# CITY OF ALBUQUERQUE

**Re: 98<sup>TH</sup> and Central Warehouse**  
**98<sup>th</sup> and Central**  
**Traffic Circulation Layout**  
Architect's Stamp 09-21-22 (K09-D052)

Based upon the information provided in your submittal received 09-27-22, the above referenced plan cannot be approved for Building Permit until the following comments are addressed:

## DRAINAGE AND TRANSPORTATION INFORMATION SHEET (REV 6/2018)

Sheet: Traffic Circulation Layout

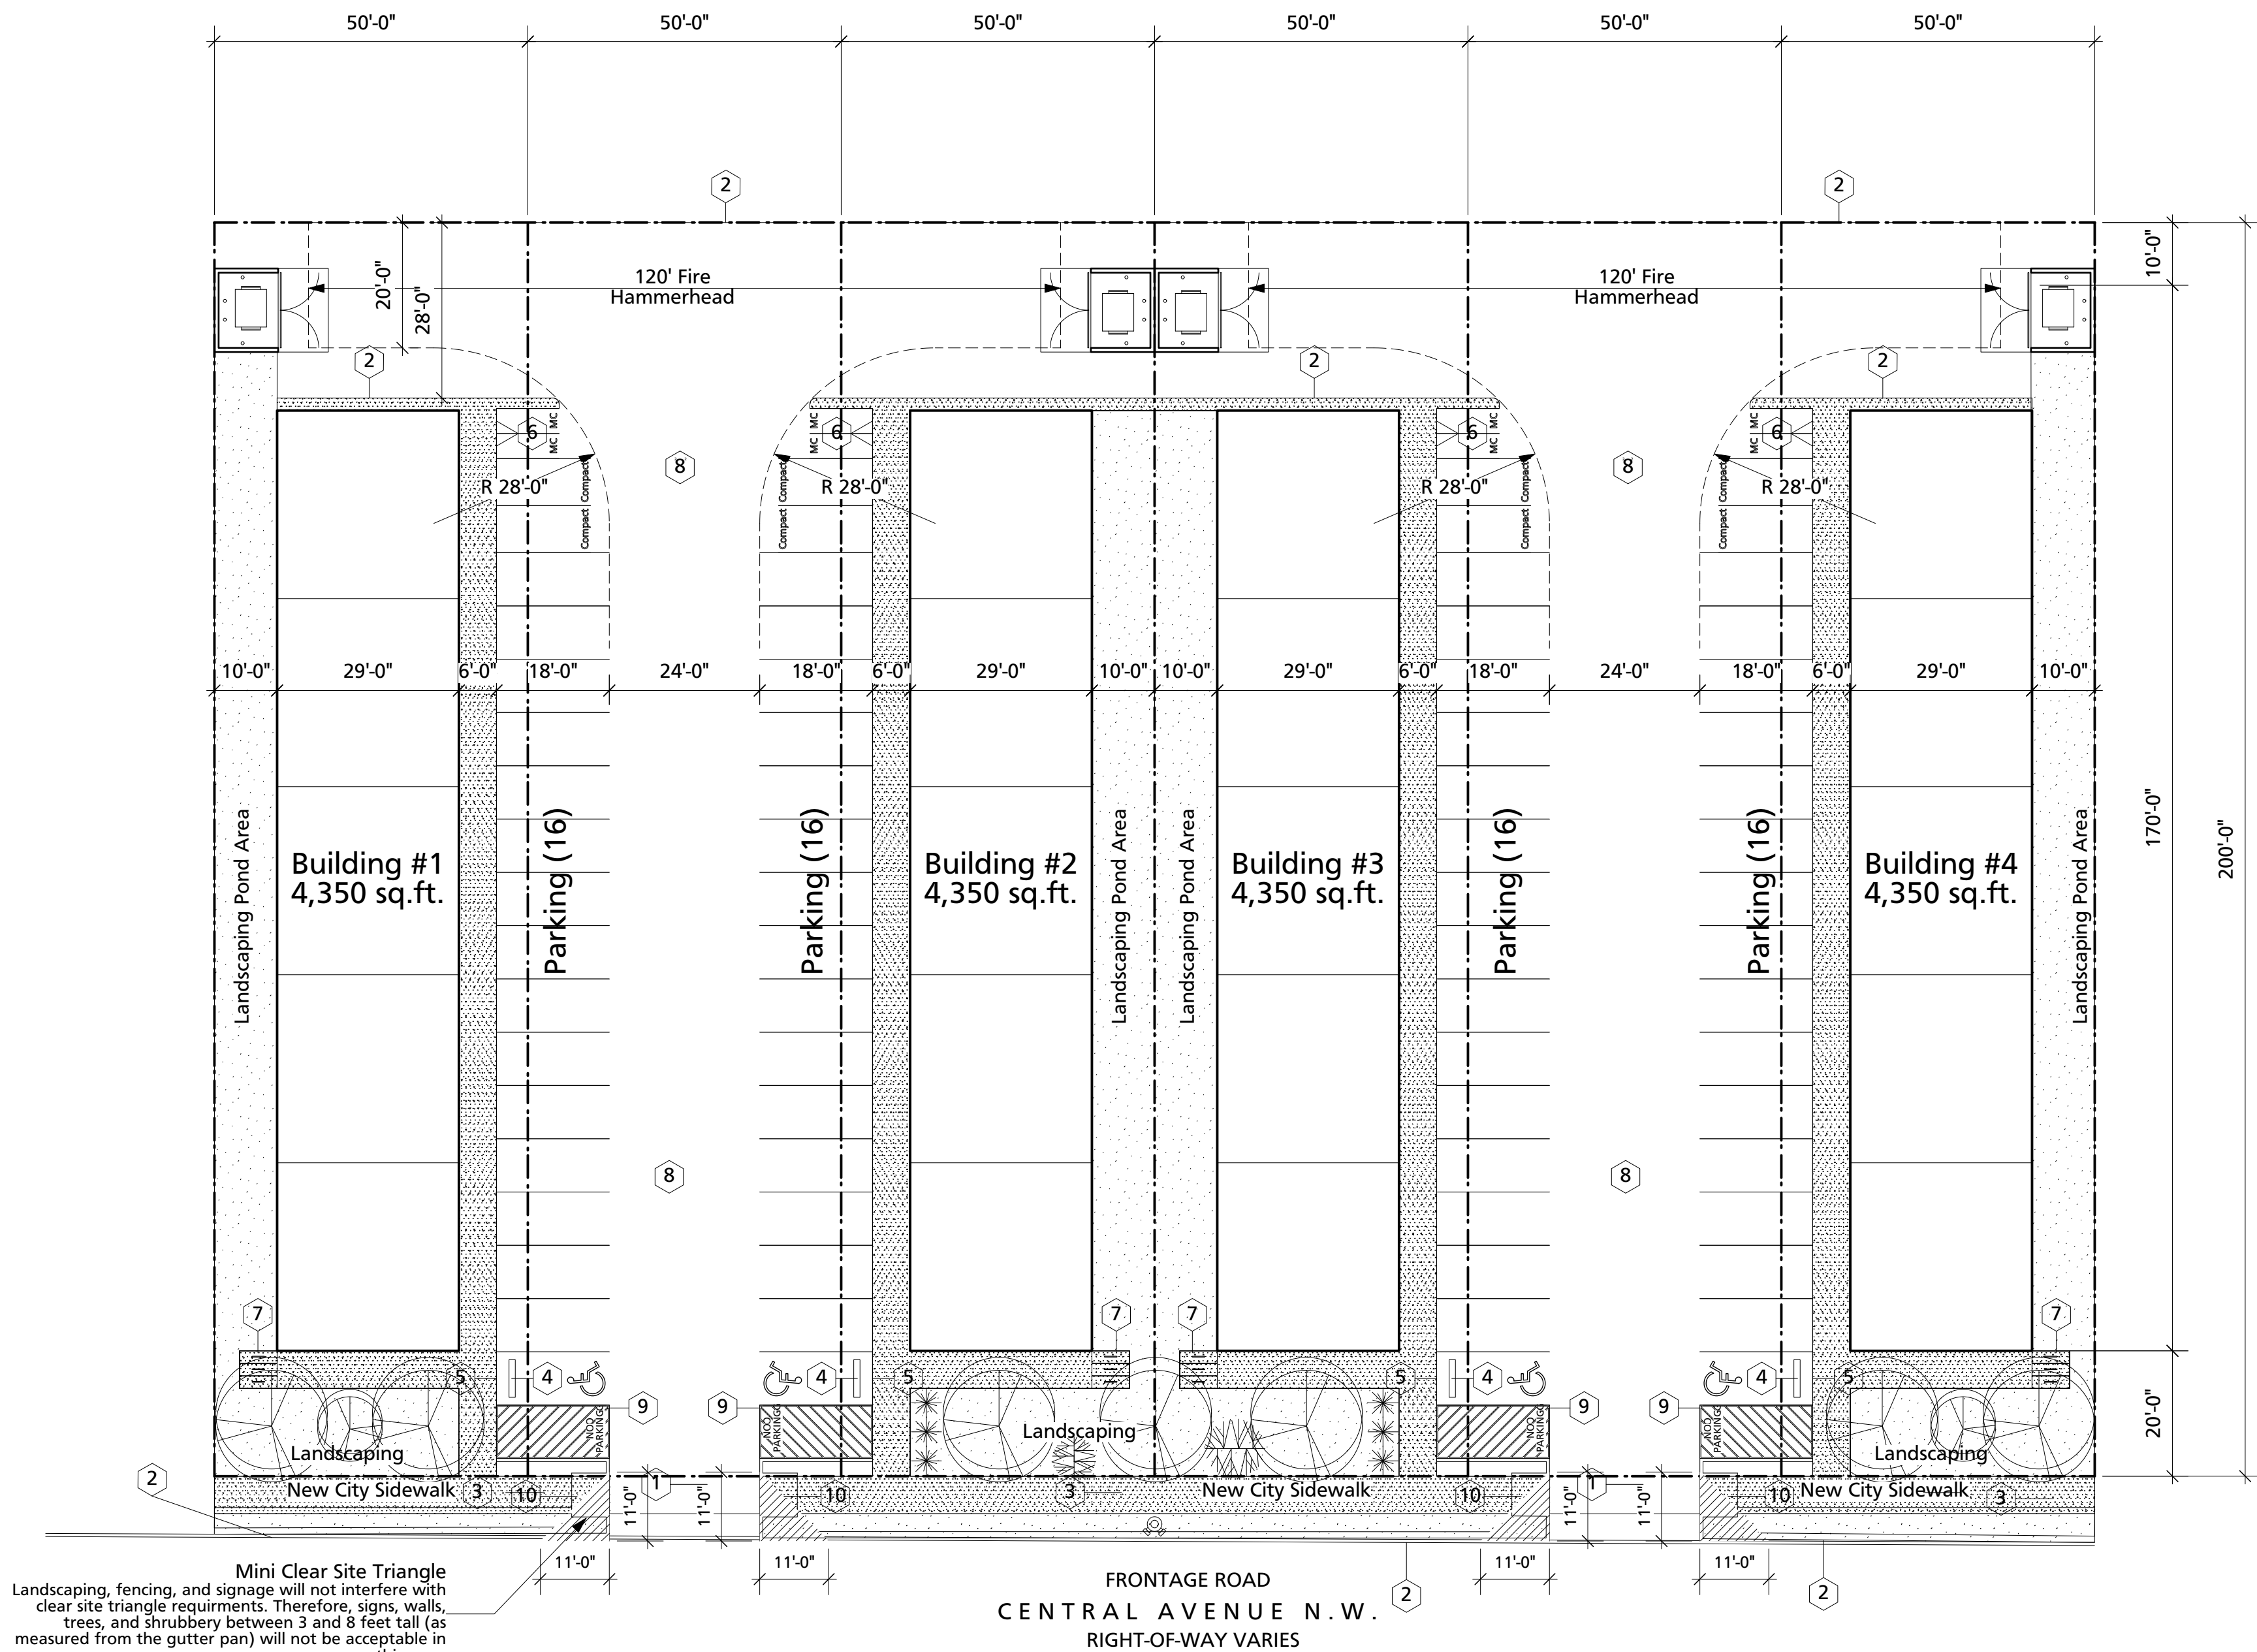
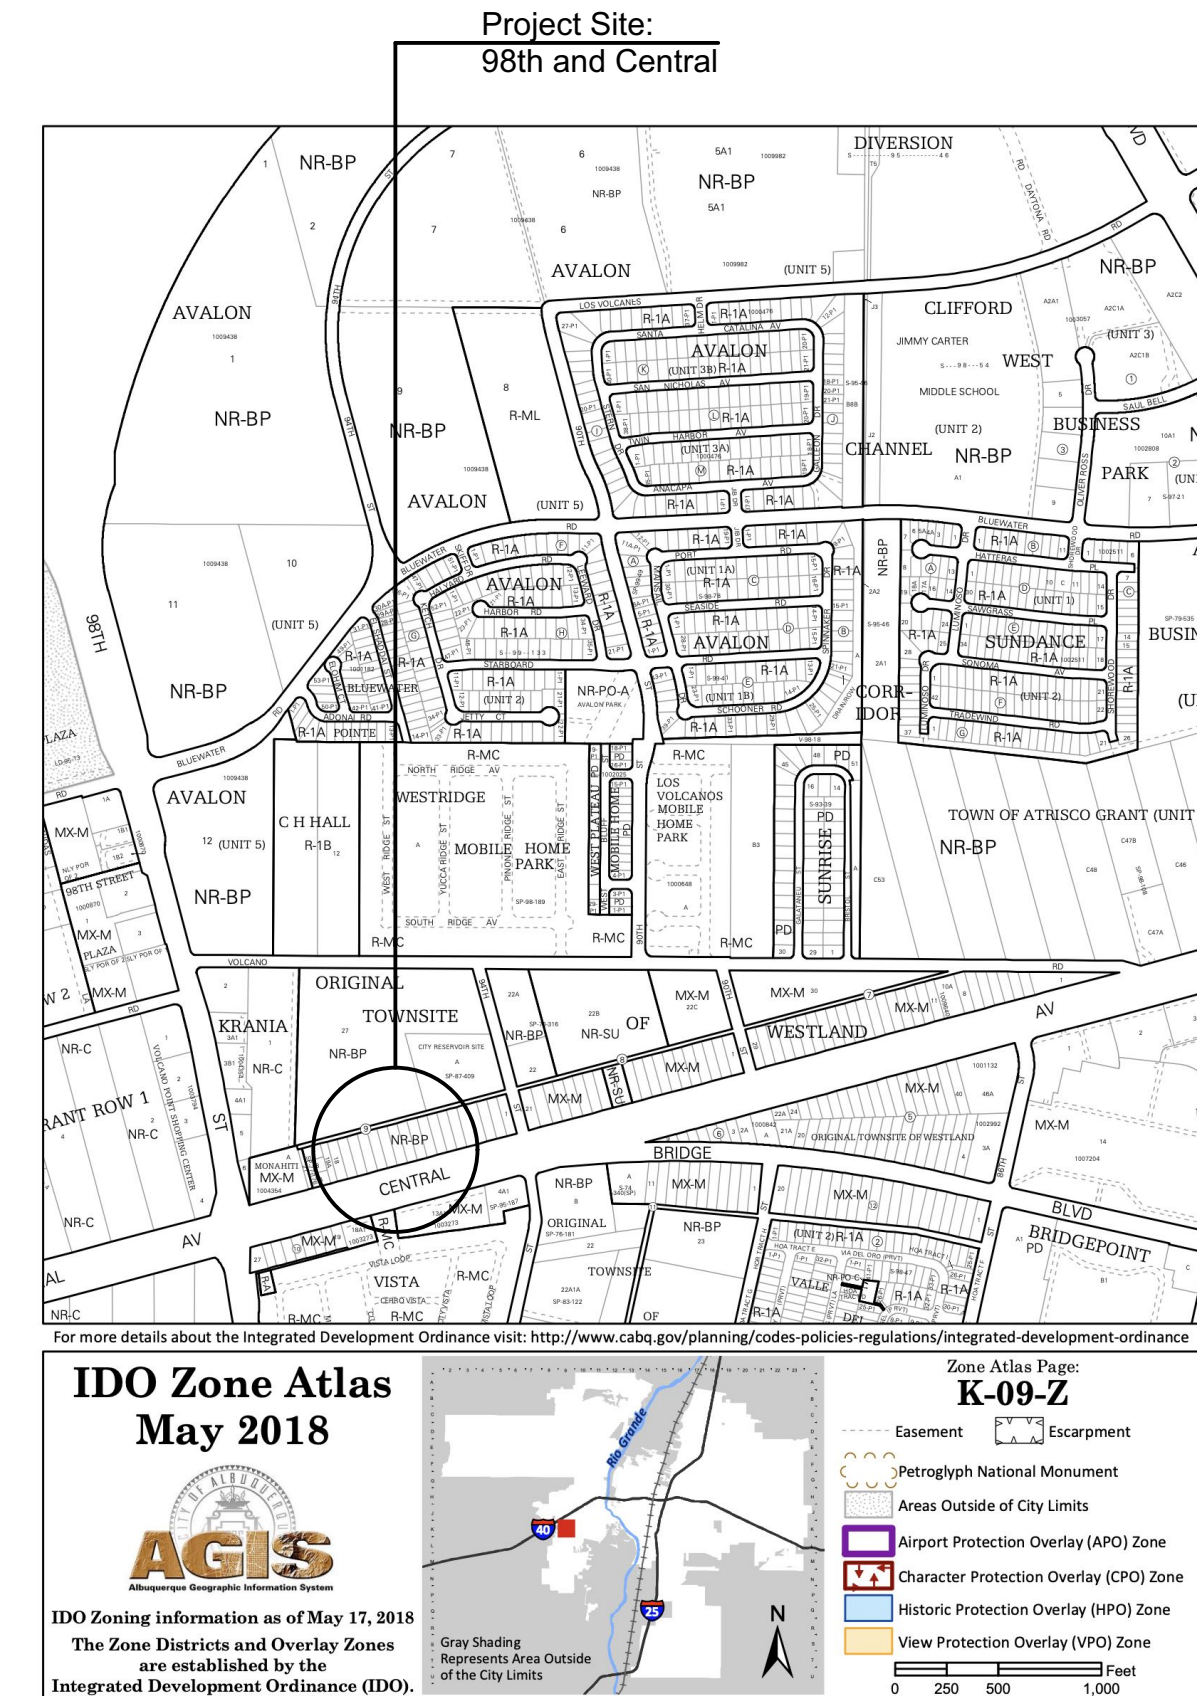
1. Curb return design need to be provided for the site accesses.
2. Please provide the width for all the proposing parking spaces.
3. Define the ADA pathway from the public sidewalk and from the ADA aisles to the building entrance, by labeling the ramps, flush, and show the building entrance on the site plan.

4. Refuse vehicle maneuvering shall be contained on-site. The refuse vehicle shall not back into the public right of way.; provide a copy of refuse approval.

5. Provide a copy of Fire Marshal approval.
6. It is not apparent what type of pavement surface is being proposed. A hard driving surface will be required as part of this proposed project for parking area and drive aisles.

7. Please specify the City Standard Drawing Number when applicable.
8. Work within the public right of way requires a work order with DRC approved plans.

9. Please add a note on the plan stating "All improvements located in the Right of Way must be included on the work order."
10. Traffic Studies: See the Traffic Impact Study (TIS) thresholds. In general, a minimum combination of 100 Vehicles entering and exiting in the peak hour warrants a Traffic Impact Study. Visit with Traffic Engineer for determination, and fill out a TIS Form that states whether one is warranted. In some cases, a trip generation may be requested for determination (Contact Matt Grush: [mgrush@cabq.gov](mailto:mgrush@cabq.gov)).
